STATE OF HAWAII
DEPARTMENT OF TRANSPORTATION
HIGHWAYS DIVISION

ADDENDUM NO. 2

**INTERSTATE ROUTE H-1 ADDITION AND MODIFICATION OF FREEWAY ACCESS
(KAPOLEI INTERCHANGE COMPLEX), PHASE 3**

FEDERAL-AID PROJECT NO. NH-H1-1(271)

FED. ROAD DIST. NO.	STATE	FED. AID PROJ. NO.	FISCAL YEAR	SHEET NO.	TOTAL SHEETS
HAWAII	HAW.	NH-H1-K(271)	2022	ADD. 27	167

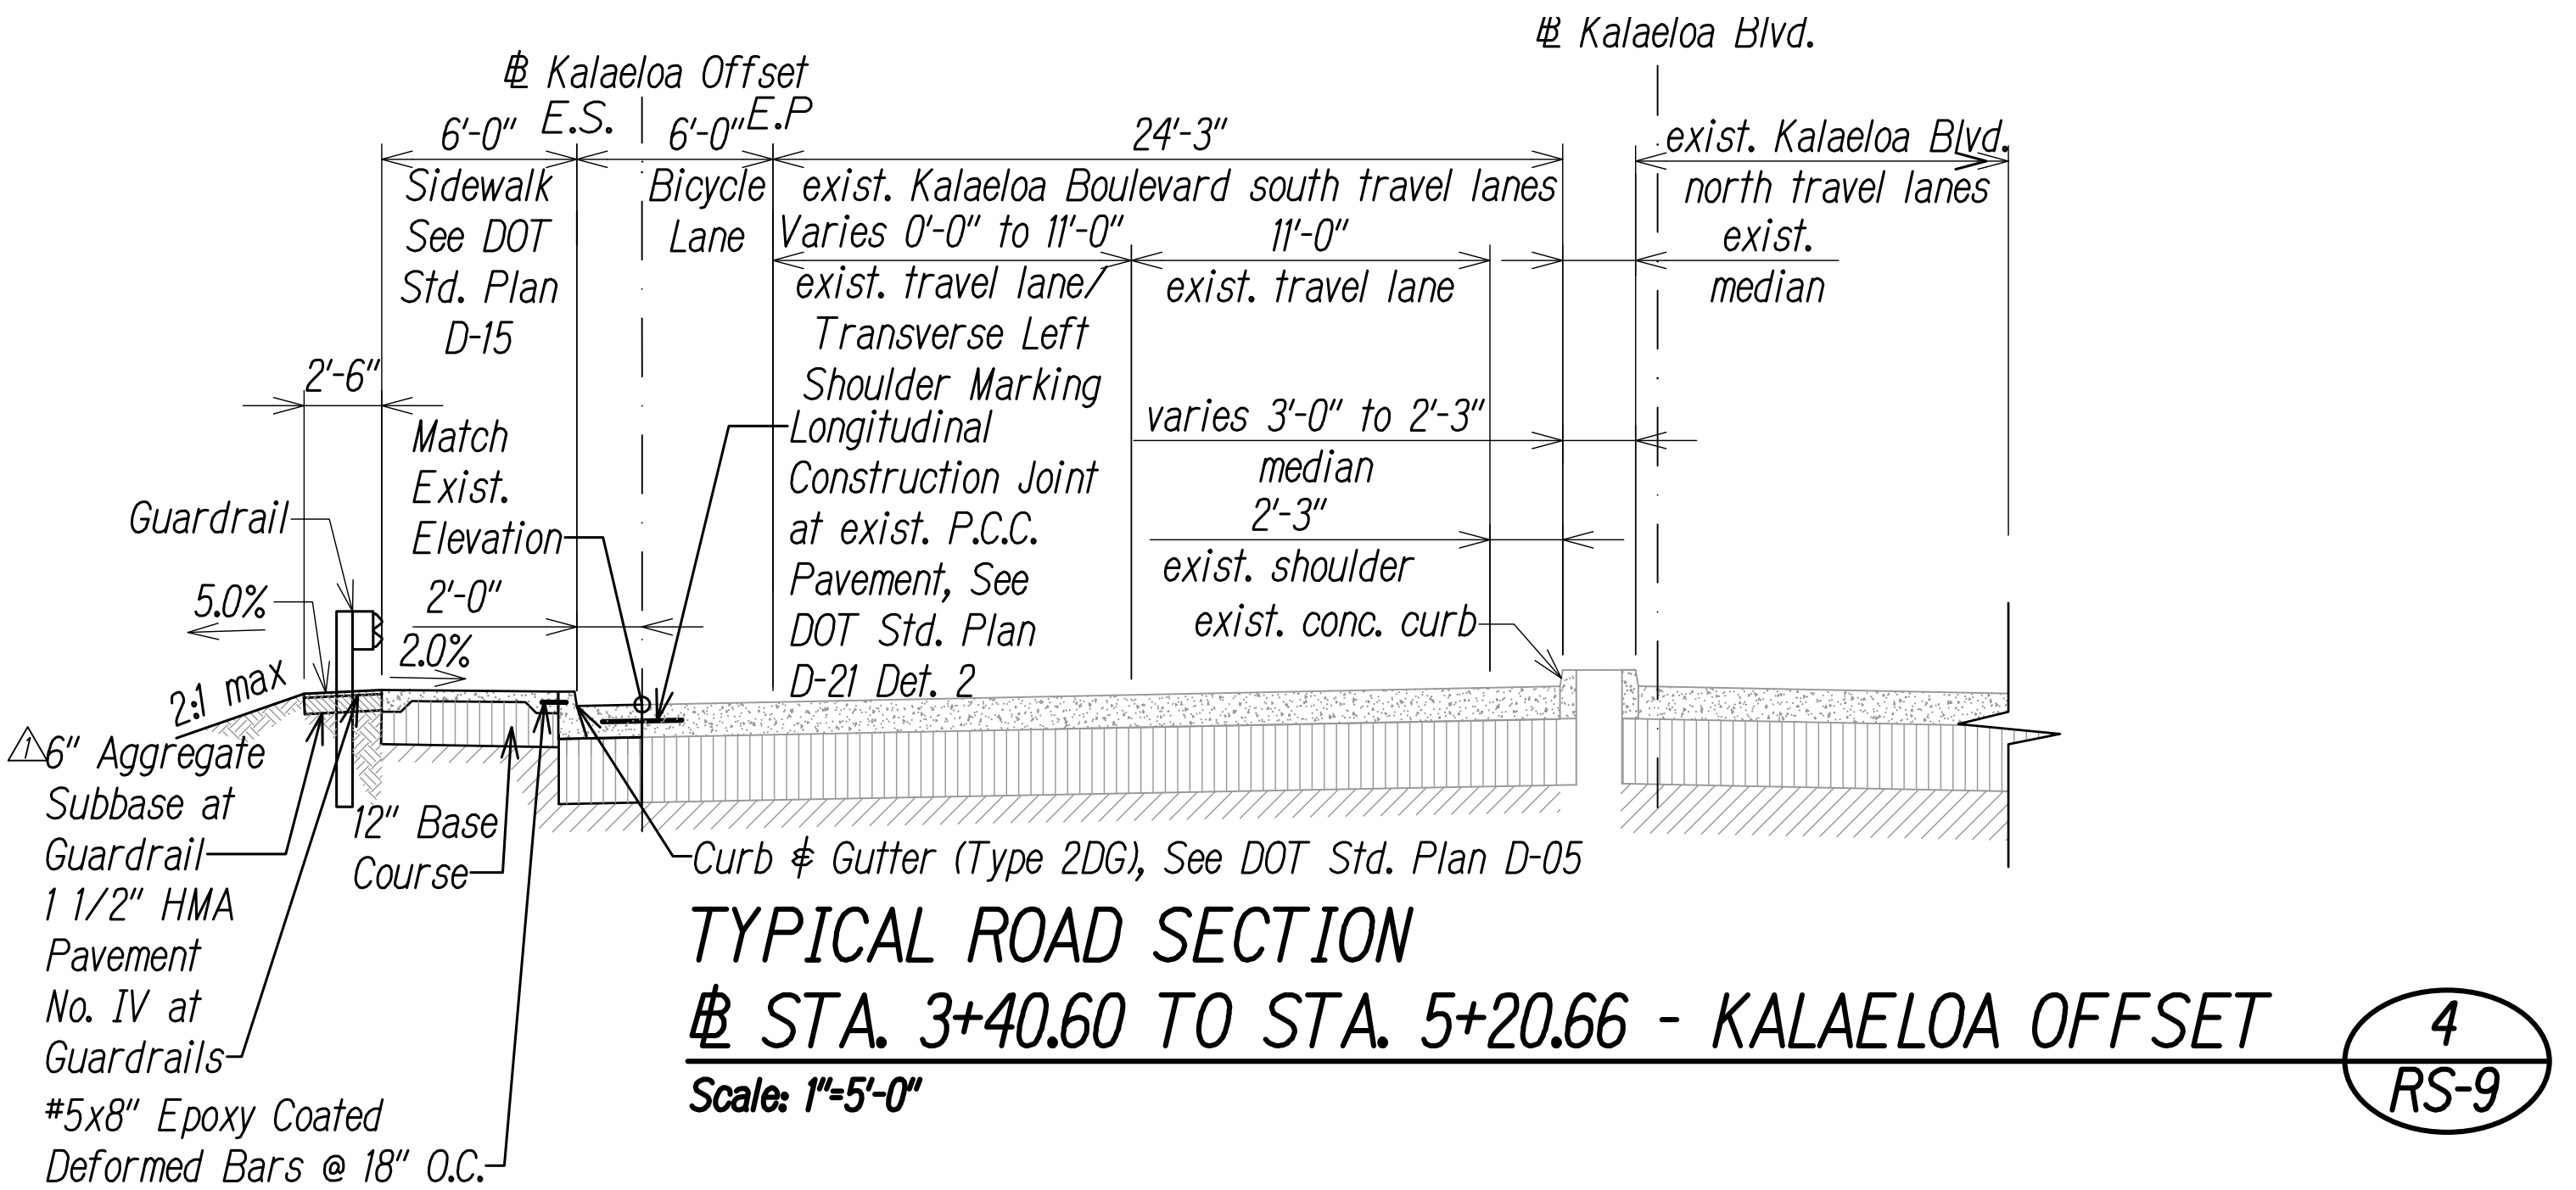
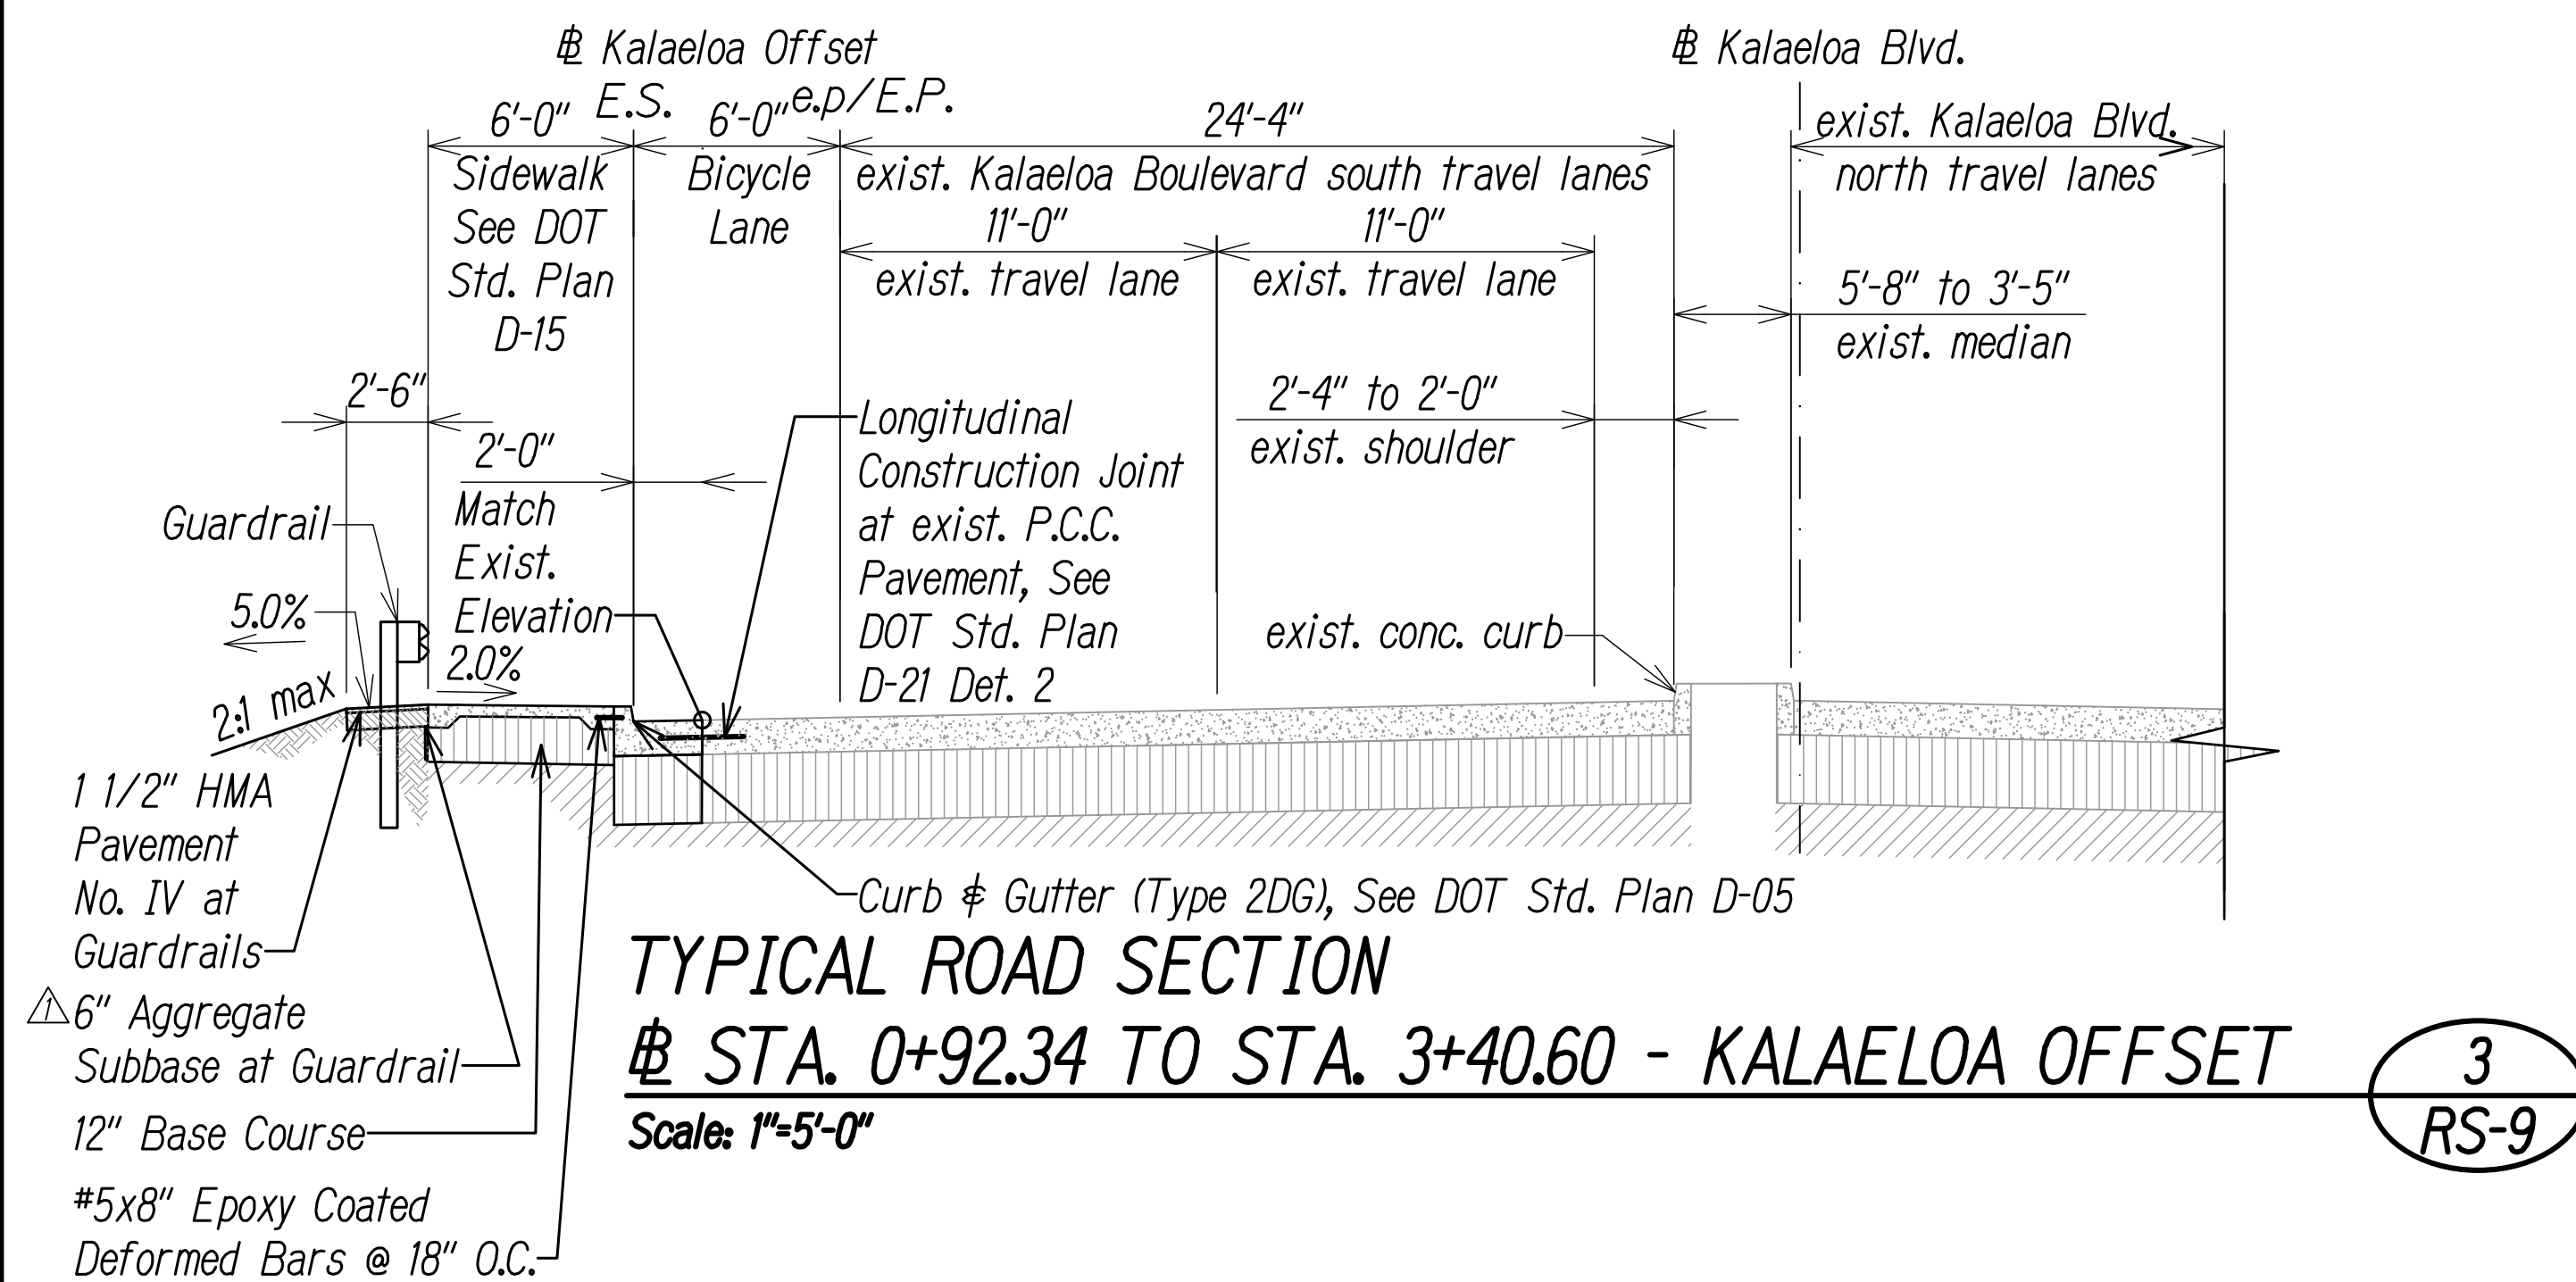
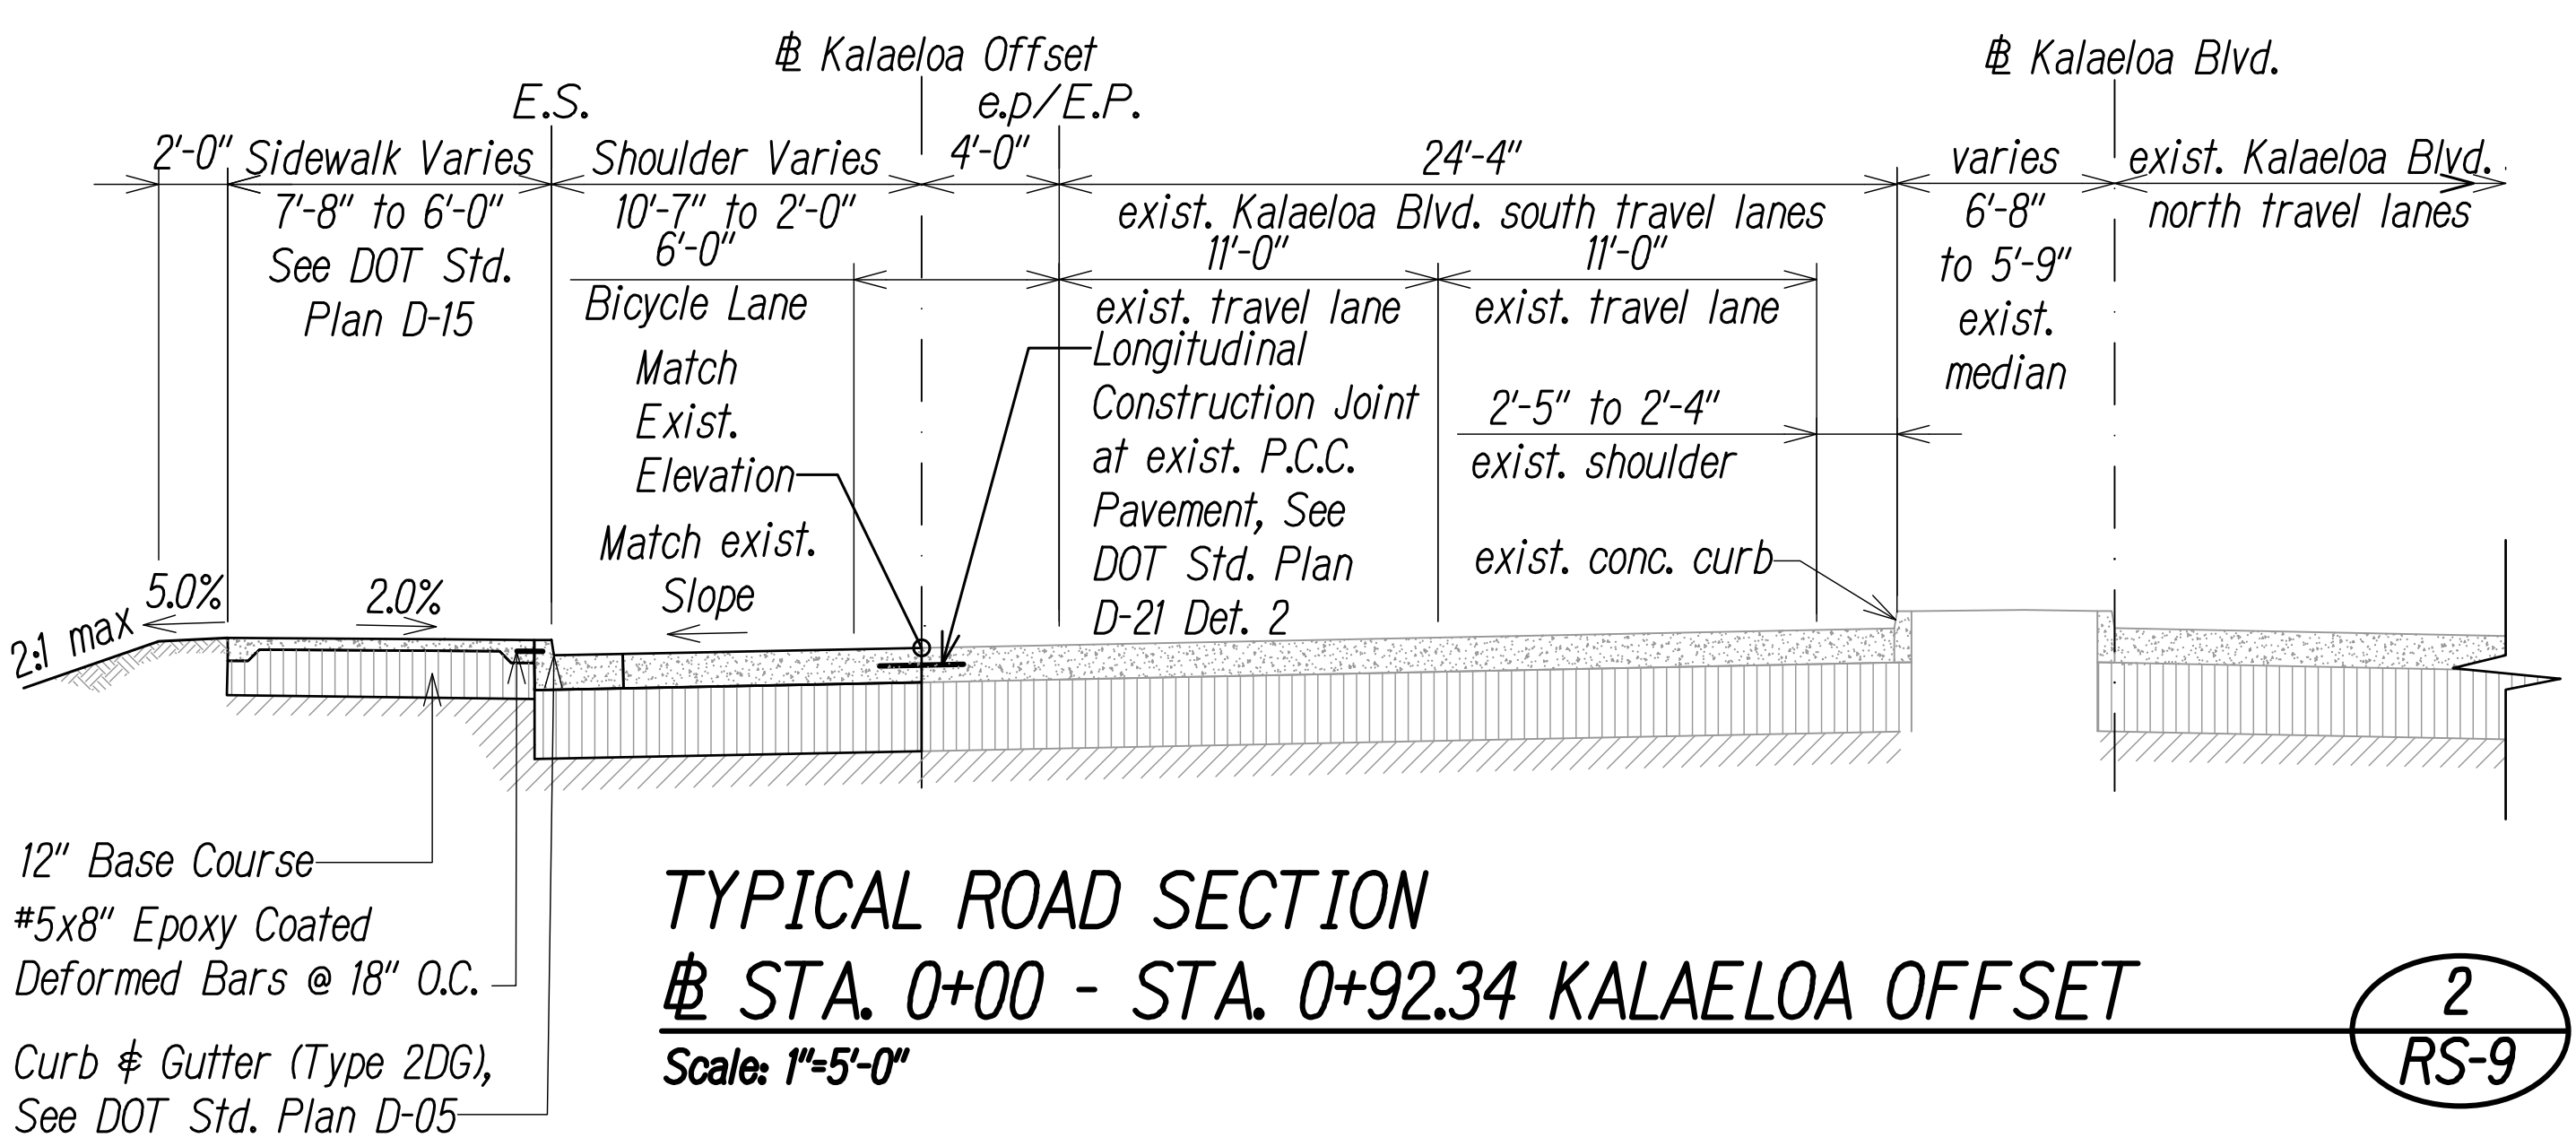
Added 6" Aggregate Subbase at guardrails	10/21/2022
REVISION	DATE
STATE OF HAWAII DEPARTMENT OF TRANSPORTATION HIGHWAYS DIVISION	
TYPICAL SECTIONS 9	
INTERSTATE ROUTE H-1 ADDITION AND MODIFICATION OF FREEWAY ACCESS (Kapolei Interchange Complex), Phase 3 Federal Aid Project No. NH-H1-K(271)	
Scale: As Noted	Date: August 2022
